GCC601X UC + Networking Convergence Solutions

PBX Firmware Release Notes

FIRMWARE VERSION 1.0.25.40 (PBX)

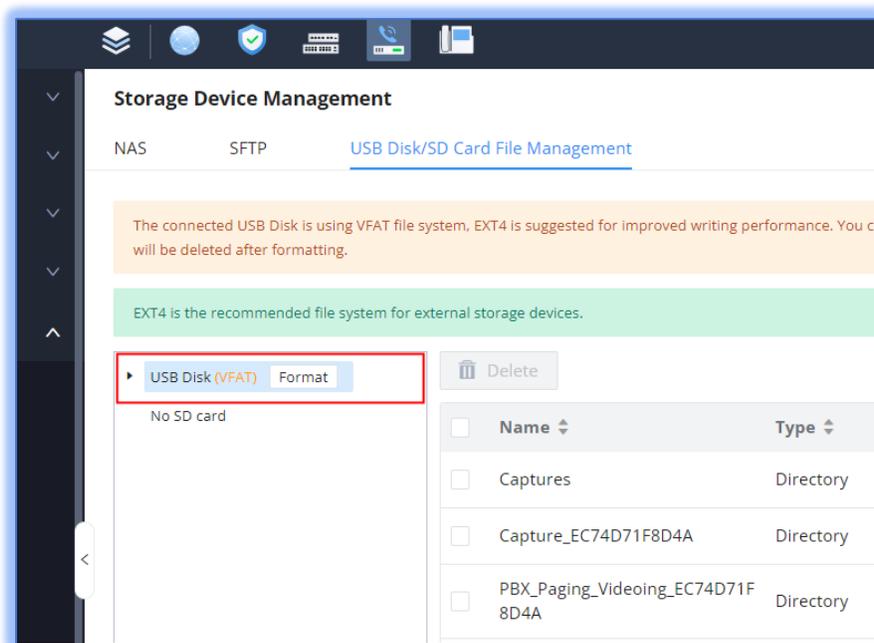
- [File Management] Added ability to format external storage as EXT4 in the *PBX Settings* → *Storage Device Management* → *USB Disk/SD Card File Management* page.
